CONSUMERS POWER COMPANY
MIDLAND ENERGY CENTER

Tracked Information Item 072.

ITEM/HOLD POINT NOTIFICATION FORM

MIDLAND NUCLEAR PLANT J.O. NO. 14509

Number NDE-PQ-RT-200, Rev. 1

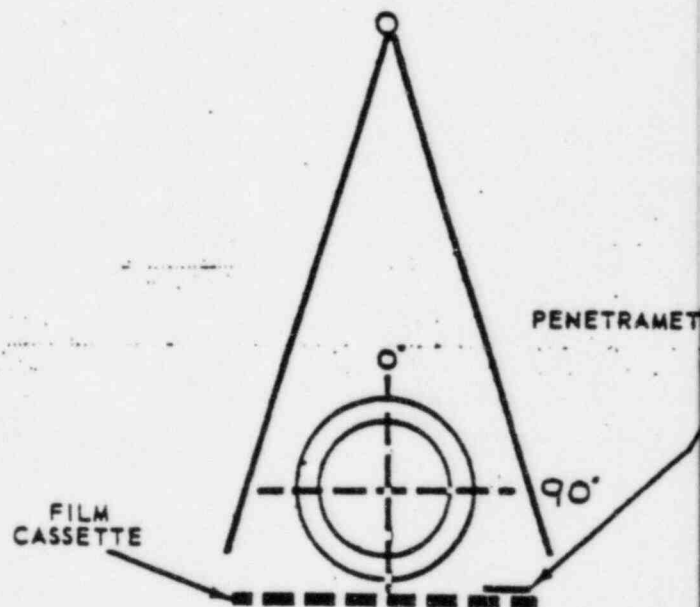
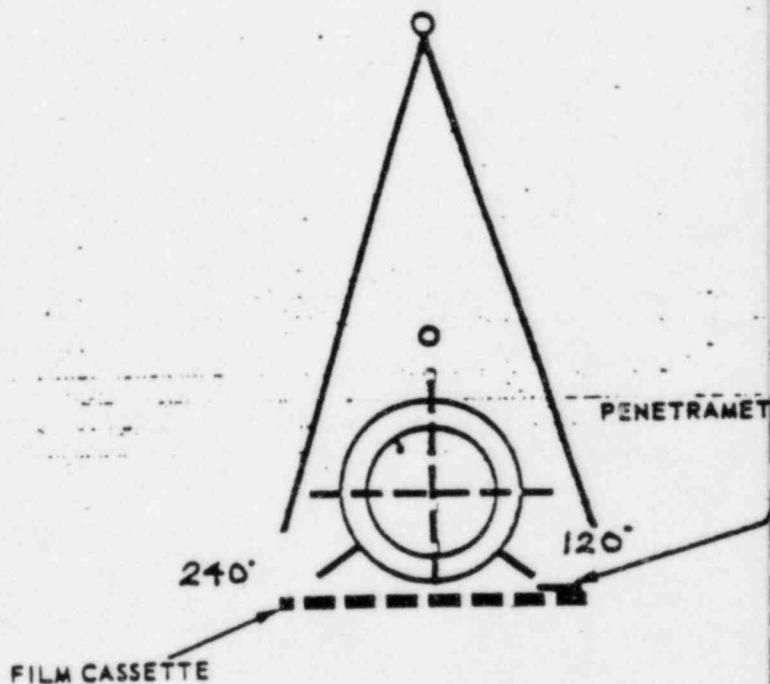
- A) Procedure NDE PQ-RT - 200 Δ consist of 3 pages
Page 1 of 3 reads: NDE-PQ-RT-200 Page 1 of 3 Revision 1
Page 2 of 3 reads: 9T-RT-200 Page 2 of 3 No Revision specified
Page 3 of 3 reads: 9T-RT-200 Page 3 of 3 No Revision specified
- B) Procedure NDE-PQ-RT-201 Δ consist of 3 pages
Pages 2 of 3 and 3 of 3 lack procedure number and revision
- C) Procedure NDE-PQ-RT-202 Δ consist of two pages
Pages 1 & 2 lack page number

Procedure NDE-PQ-RT-200 Revision 1, Page 2 of 3 and Page 3 of 3, have been annotated with PQ-RT-200 Revision 1.
